# Access Compliance Report

## Public Rights-of-Way

### (Curb Ramps)

Intersection ID: 28932	Main Street: GIBBONS_LINK_RD	Cross Street: BRANDIE_GLEN_RD	Location:	E
ADA ID: B92F53E714C1	Ramp Type: Directional1	Initial Pass/Fail: Fail	Overall Compliance: No	Severity Score: 25
Codes/Mitigation Info/Possible Solution		Field Measurements/Component Compliance

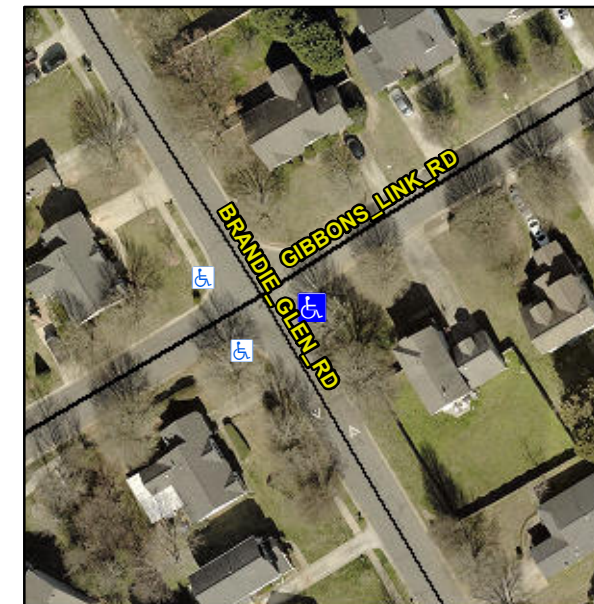
Compliance	Description	Data	Compliance	Description	Data
N/A	Ramp Length (in)	49.0	N/A	Grade Break?	N/A
Yes	Ramp Width (in)	58.5	N/A	Grade Break Slope (%)	0.0
No	Ramp Slope (%)	13.8	N/A	Grade Break XSlope (%)	0.0
Yes	Ramp XSlope (%)	2.0			
N/A	Flare Type LT	N/A	N/A	Flare Type RT	N/A
N/A	Flare Slope LT (%)	N/A	N/A	Flare Slope RT (%)	0.0
N/A	Flare Traversable LT?	N/A	N/A	Flare Traversable RT?	N/A
N/A	Landing Length (in)	0.0	N/A	DWS Provided?	N/A
N/A	Landing Width (in)	0.0	N/A	DWS Contrast?	N/A
N/A	Landing Slope (%)	0.0	N/A	DWS Length (in)	N/A
N/A	Landing X Slope (%)	0.0	N/A	DWS Full Width?	N/A
N/A	Landing Curb? (Y/N)	N/A	N/A	DWS Offset LT (in)	N/A
N/A	Shared Landing?	N/A	N/A	DWS Offset RT (in)	N/A
N/A	Gutter Ponding?	0.0	N/A	Gutter Slope (%)	N/A
N/A	Gutter Lip Ht (in)	0.0	N/A	Gutter X Slope (%)	N/A
N/A	Painted X Walk1?	No		Road Slope (%)	0.9
	X Walk 1 Direction	To NW		Road X Slope (%)	0.5
	X Walk 1 Width (in)	N/A		Clear Space?	N/A

X Walk 1 Slope (%)	0.9	N/A	Clear Space to XWalk (in)	N/A
	X Walk 1 X Slope (%)	0.5	N/A	Storm Grate/Utility Hazard?	N/A
N/A	Ramp inside XWalk1?	N/A		Storm Grate/Utility Type	
N/A	Any Obstructions?	N/A			N/A
	Obstruction Type		Yes	Surface Condition? (G/P)	Good
			N/A	Curb Slope (%)	N/A

**Remove & Replace Entire Ramp.**
